Technical Service Bulletin: tsb100166

New Cam Follower Shaft Dowel Rings

This Technical Service Bulletin introduces a new ring dowel for the cam follower assemblies of the QST30 engine.

04a00021

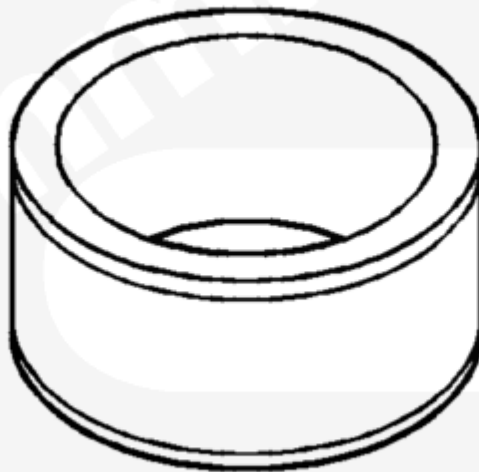
The affected applications are all QST30 engines made prior to August 16, 2001 and prior to engine serial number 37199919. This change is implemented due to a possible assembly issue with the previous ring dowels. The old dowels were soft enough to mislocate and deform upon initial installation, thus possibly mislocating the cam follower shaft and causing capscrew clamp load problems. No stock of the old dowel is left in factory production, as of September 17, 2001

Engine serial first for the new, hardened dowel rings is 37199919, built August 16, 2001. This new dowel ring, Part Number 4067993, supersedes Part Number 3092504 for the cam follower assemblies **only**.
